**Flood Control Project Maintenance
Levee Inspections**

Maintenance Issue Types Only, Levee Inspection Report By Mile - Fall 2023

Reclamation District No. 0785 Driver

Waterway	Bank	Unit Miles	Inspection Start/End	Inspector
Unit No. 01 Sacramento River	Right	2.26	09/28/2023 09/28/2023	Nate Hicks

Photo 1 of 1 : FA_2023_RD0785_185_12_20230927_00005.jpg

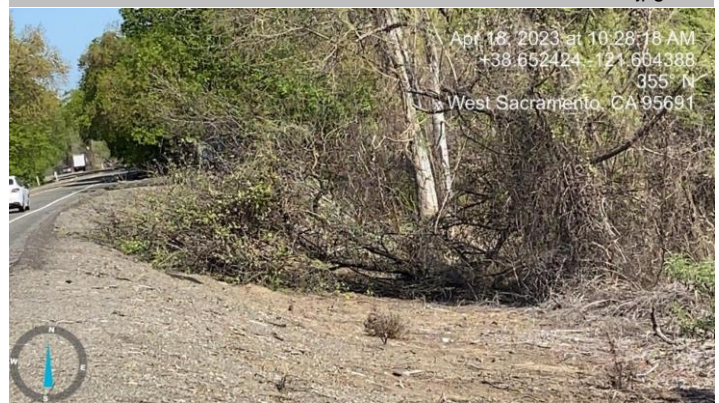
LM Start	0.81	Rating **	M	Issue No.	12
LM End	0.81	Issue Type +	Ma	Location *	WS
Category	Earthen Levee			GPS Latitude/Longitude	
				Start	End
Item	Trim / Thin Trees			38.652424°	38.652424°
				-121.604388°	-121.604388°
DWR ID	DWR_RD0785_01_s_2023_12				
Comment Code					
T2 : Tree or limb.					
Inspector Comment

View of fallen tree on levee slope (Spring 2023).

Photo 1 of 1 : FA_2023_RD0785_185_18_20230928_00020.jpg

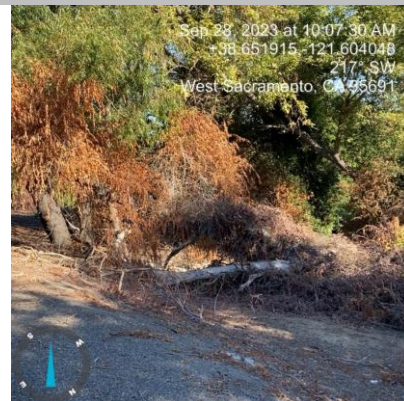
LM Start	0.85	Rating **	M	Issue No.	18
LM End	0.85	Issue Type +	Ma	Location *	WS
Category	Earthen Levee			GPS Latitude/Longitude	
				Start	End
Item	Trim / Thin Trees			38.651915°	38.651915°
				-121.604048°	-121.604048°
DWR ID	DWR_RD0785_01_f_2023_18				
Comment Code					
T2 : Tree or limb.					
Inspector Comment					
Remove fallen tree and limbs off of levee slope.

View of fallen tree and limbs on waterside slope (Fall 2023).

Photo 1 of 1 : FA_2023_RD0785_185_8_20230927_00002.jpg

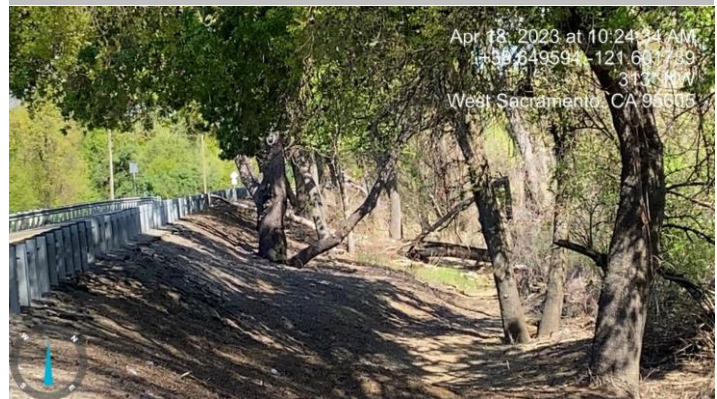
LM Start	1.05	Rating **	M	Issue No.	8
LM End	1.05	Issue Type +	Ma	Location *	WS
Category	Earthen Levee			GPS Latitude/Longitude	
				Start	End
Item	Trim / Thin Trees			38.649594°	38.649594°
				-121.601739°	-121.601739°
DWR ID	DWR_RD0785_01_s_2023_8				
Comment Code					
T2 : Tree or limb.					
Inspector Comment

View of fallen trees on levee slope (Spring 2023).
